UNIT: XL402		MIDAS AUDIO	
TITLE: INPUT POD		DATE: DEC 95	
DRAWN: JRC.		SHEET: 1 OF 5	
CHECKED:		DRG No. XL402.SCH	
BOARD No. B2767 BOARD iss. 2		SHEET iss. 5	
PHASE PIN 1 TO A 2V7 ZENER DIODE	ISS.	DATE.	
5	27/8/95		
6	27/8/95		
AMMENDMENTS

MIDAS AUDIO	
UNIT: XL402	DATE: DEC 95
TITLE: INPUT POD	SHEET: 2 OF 5
BOARD No. B2767 BOARD iss. 2	CHECKED: DRG No. XL402.SCH
AMENDMENTS	ISS, INT, DATE.

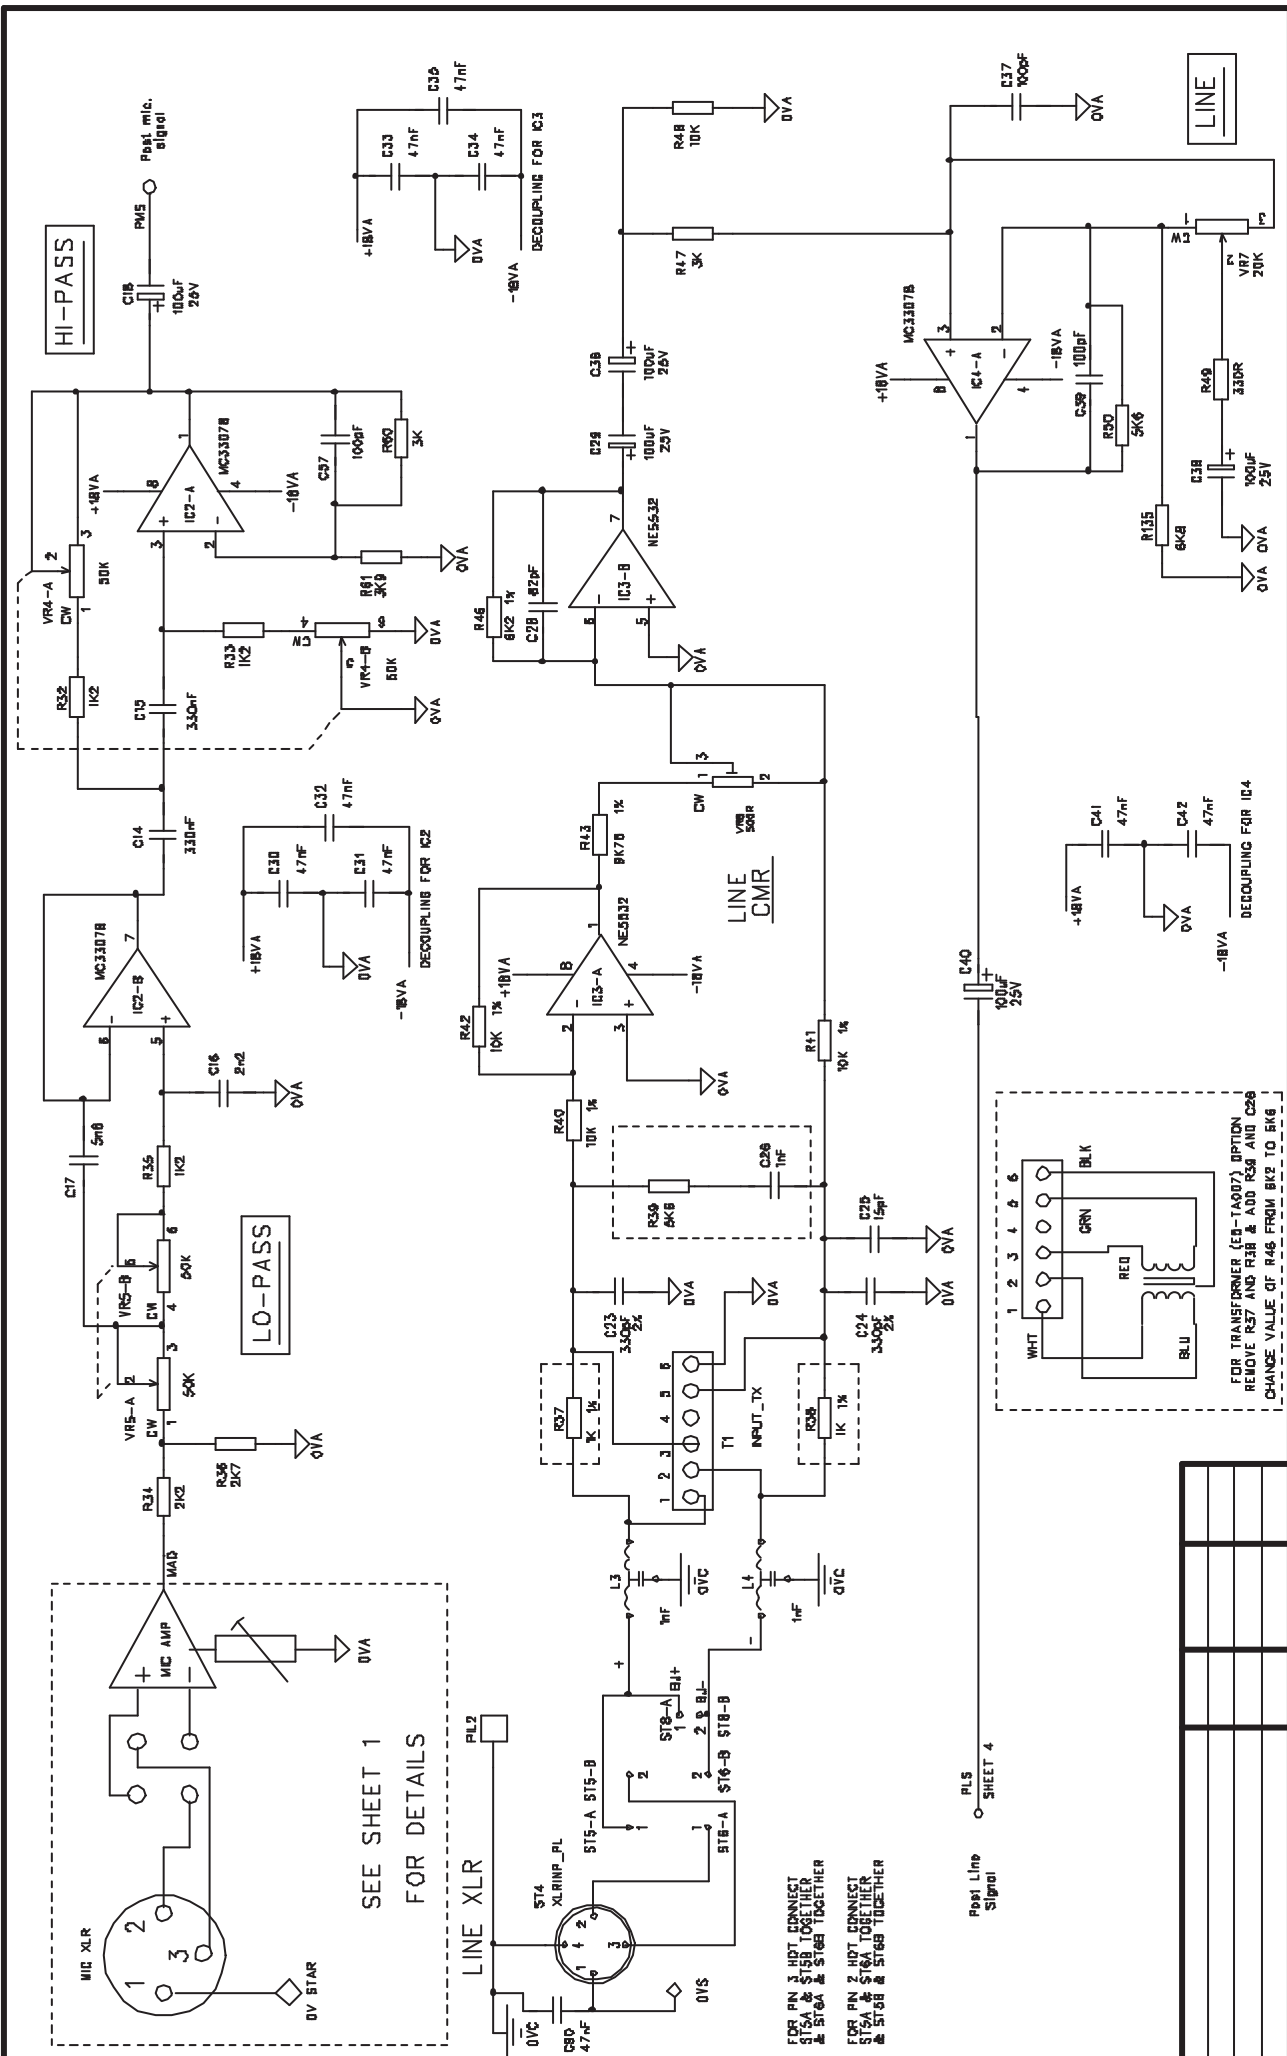
FOR PIN 3 HOT CONNECT
 ST2A & ST2B TOGETHER
 & ST3A & ST3B TOGETHER

FOR PIN 2 HOT CONNECT
 ST2A & ST3A TOGETHER
 & ST2B & ST3B TOGETHER

UNIT: XL402		MIDAS AUDIO	
TITLE: INPUT POD		DRAWN: JRC.	
BOARD No. B2767		DATE: DEC 95	
BOARD iss. 2		SHEET: 4 OF 5	
CHECKED:		SHEET iss. 5	
AMMENDMENTS		DRG No. XL402.SCH

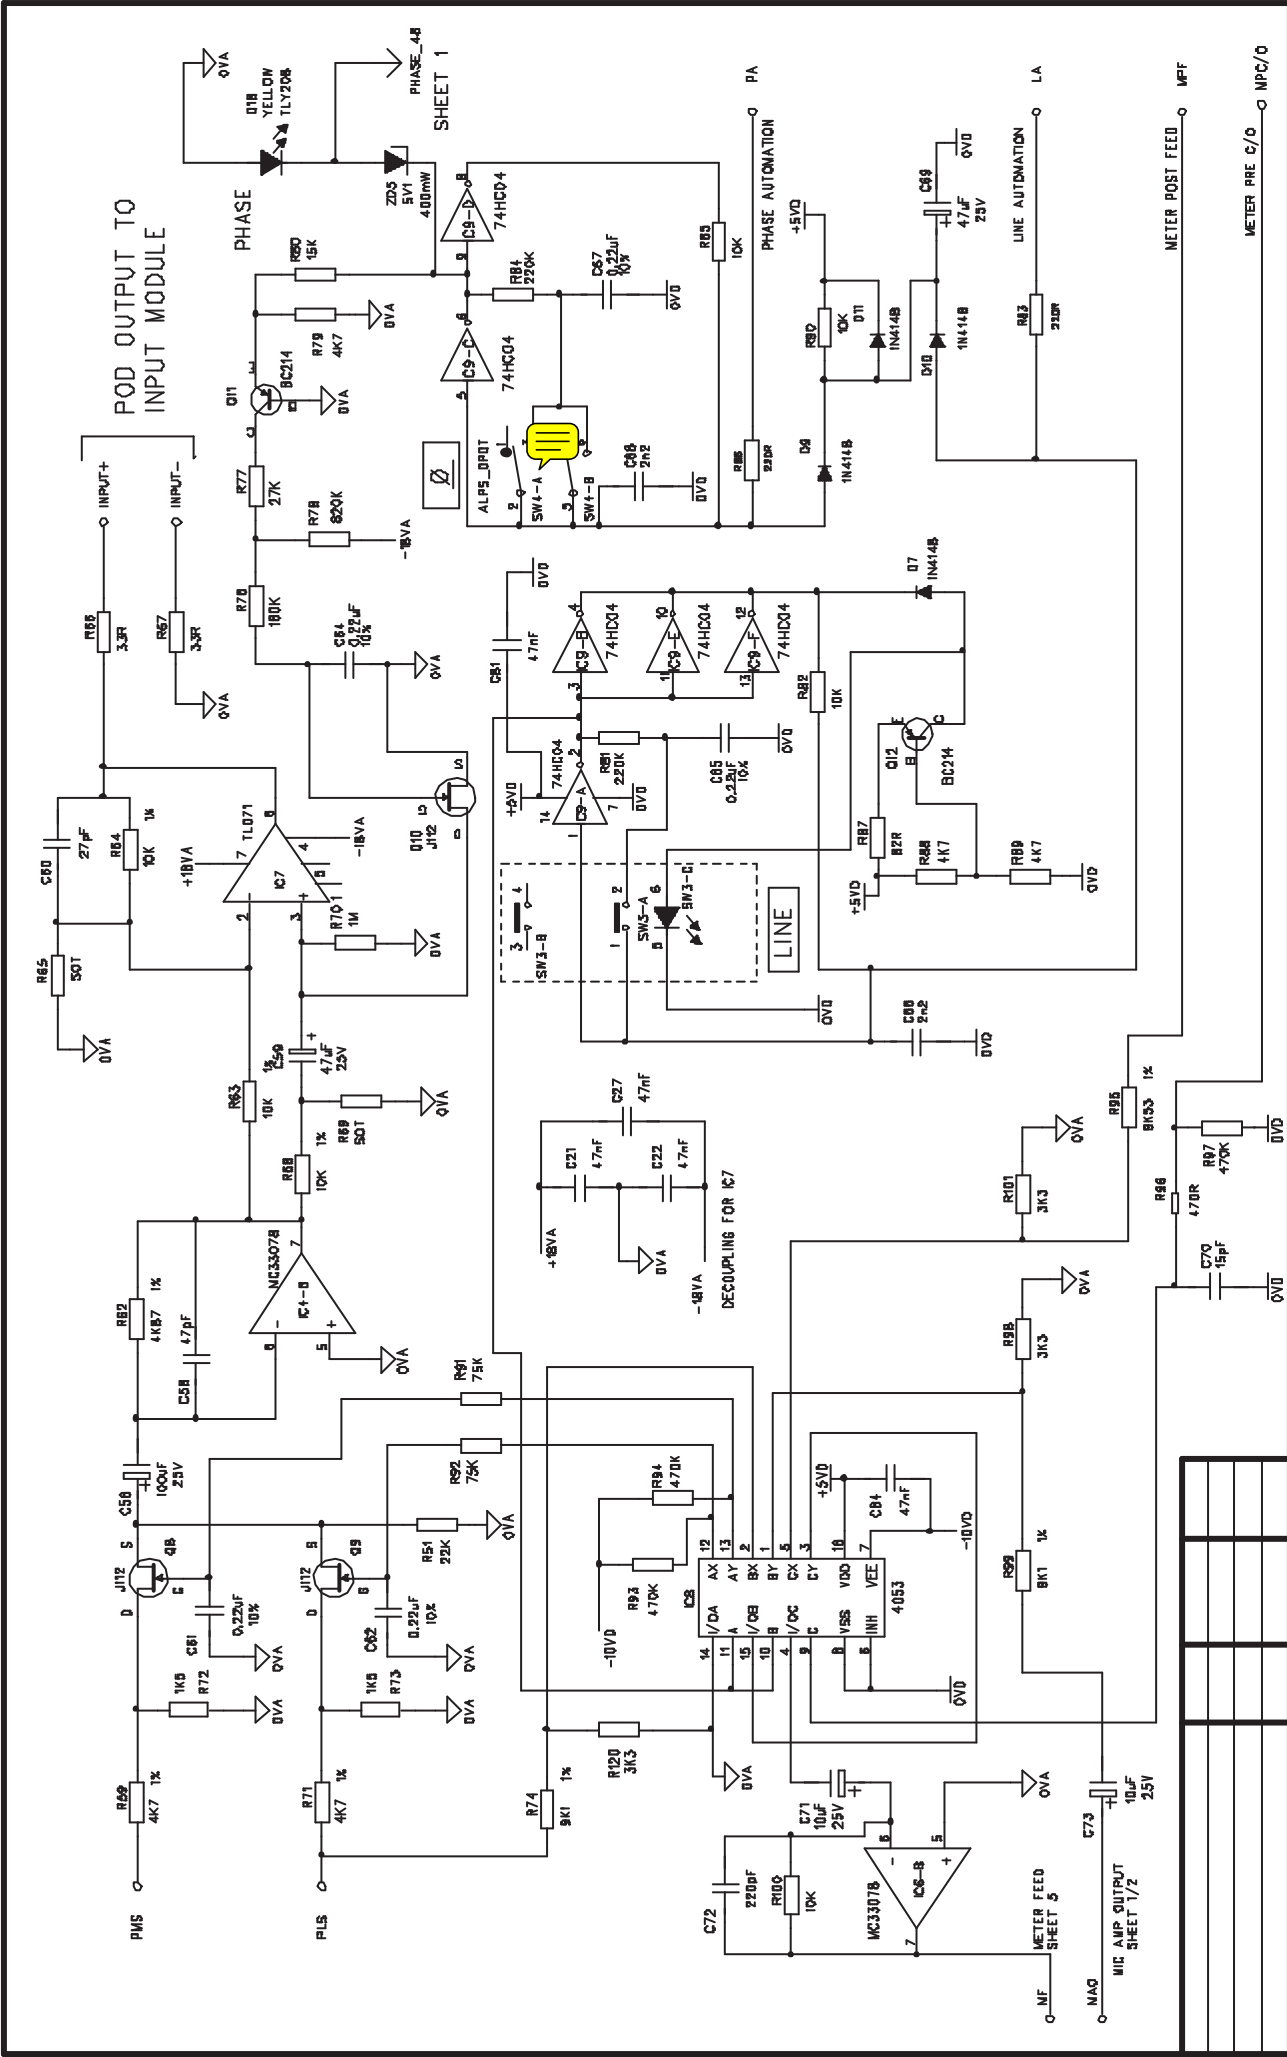
CHANGE C65 & C66 FROM 1000pF TO 2n2	4	JRC.	4-12-85
CHANGE R63 & R66 FROM 100R TO 220R	4	JRC.	4-12-85
AMMENDMENTS	ISS.	INT.	DATE.

UNIT: XL402	DATE: DEC 95	SHEET: 5 OF 5
TITLE: INPUT POD	DRAWN: JRC.	SHEET iss. 5
BOARD No. B2767	BOARD iss. 2	DRG No. XL402.SCH

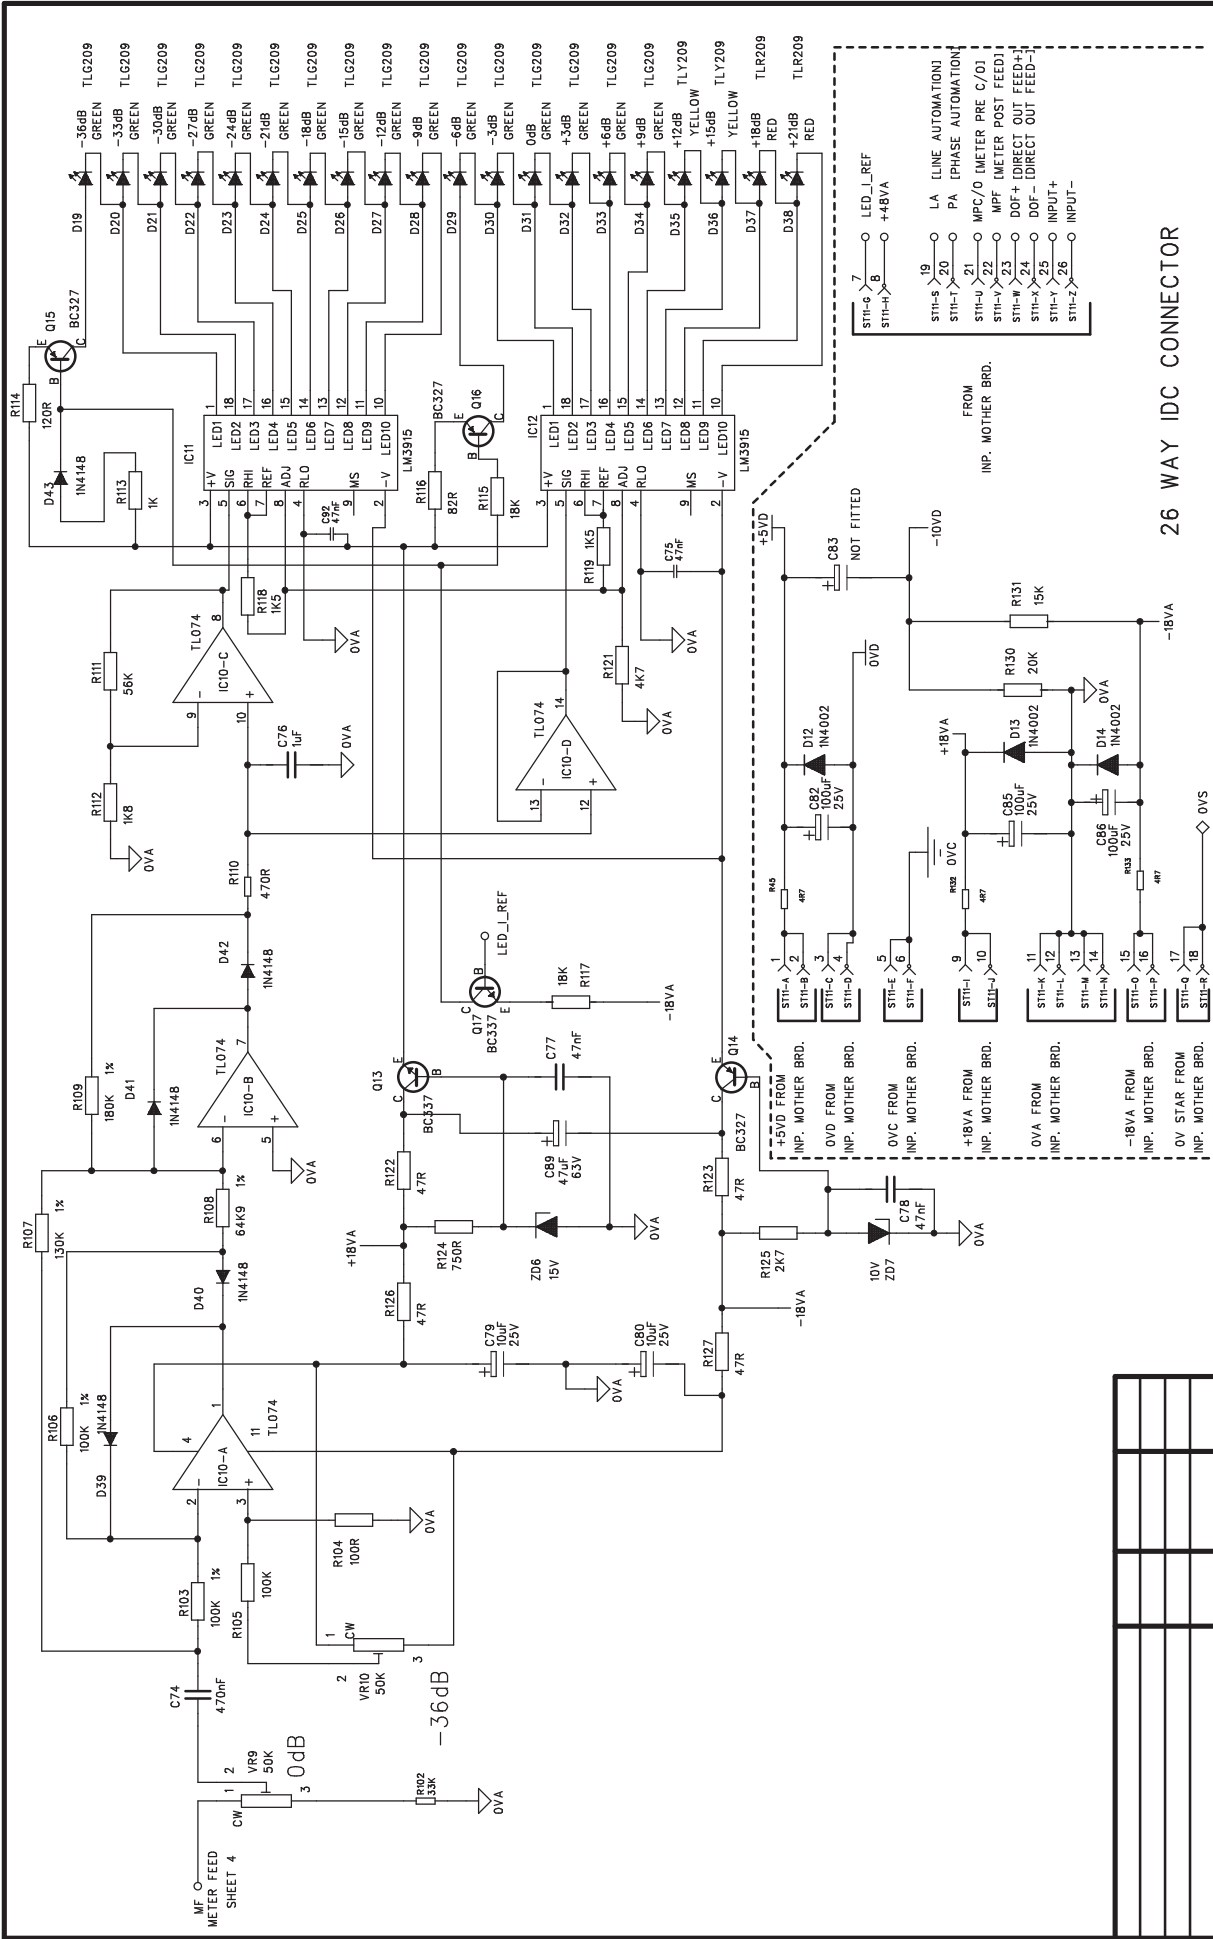
CHANGE	ISS.	INIT.	DATE.
CHANGE R102 from 58K to 33K	5	JRC	AUG 96
CHANGE VALUE OF C83 FROM 100uf TO NOT FITTED	3	JRC	OCT 95
CHANGE D38 & D35 TO D1-A1207 (LEDY207)			
CHANGE R91 & R92 TO 470K 5%			
AMMENDMENTS
